MONTGOMERY COUNTY PLANNING DEPARTMENT
THE MARYLAND-NATIONAL CAPITAL PARK AND PLANNING COMMISSION

MEMORANDUM

REVIEW TYPE: Preliminary Plan of Subdivision

PROJECT NAME: Kensington Heights
CASE #: 1201010290
REVIEW BASIS: Chapter 50, Montgomery County Subdivision Regulations

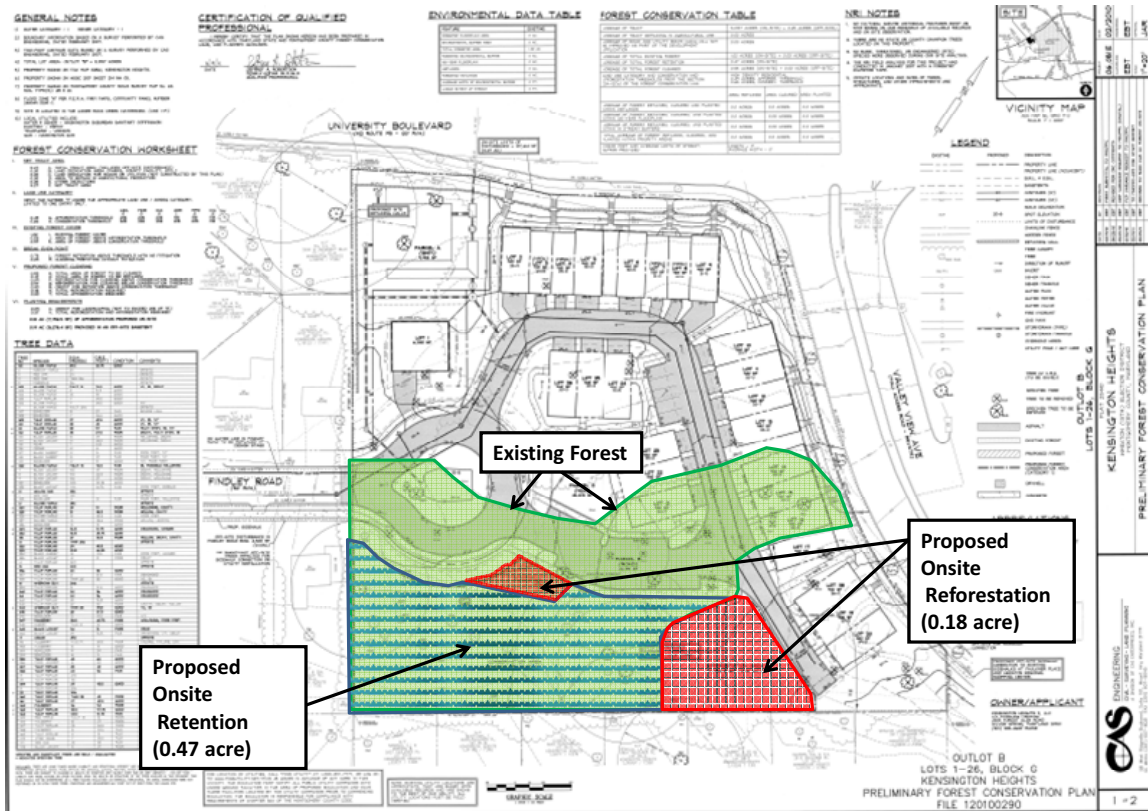
For this site, the applicable conservation threshold is 0.65 acres. The Forest Conservation Law allows for some flexibility of the above requirement for onsite forest retention. Section 22A-12(f)(3) states that “if the Planning Board or Planning Director, as appropriate, finds that forest retention required in this subsection is not possible, the applicant must provide the maximum possible on-site retention in combination with on-site reforestation and afforestation, not including landscaping.” That is, if onsite forest retention cannot be used to partly or entirely meet the conservation threshold amount, then onsite forest planting may be used to meet this threshold amount.

Originally, the applicant proposed a subdivision with 27 lots with no onsite forest retention and 0.44 acres of onsite forest planting. This proposal would not be in conformance with Sections 22A-12(f)(2)(B) and (f)(3) and the applicant would have had to request a waiver from these provisions.

However, the applicant has revised the subdivision to delete one of the one-family detached lots, convert a second one-family detached lot into a townhouse lot, and re-arrange the remaining lots to create a 0.65-acre combined onsite forest retention and planting area. The revised layout does not provide the entire onsite forest through retention alone. This is because the density of the RT-8 zone, in combination with infrastructure requirements such as the full cul-de-sac at the public road termination on the site, limits the amount of forest retention that can occur onsite. Staff believes that the maximum forest retention is provided by the revised layout and is in conformance with Section 22A-12(f)(3).

The proposed subdivision complies with the Forest Conservation Law’s minimum onsite forest requirement for an optional method of development in a one-family residential zone (Section 22A-12(f)(2)(B)) and provides the maximum possible on-site forest retention in combination with onsite reforestation (Section 22A-12(f)(3)).
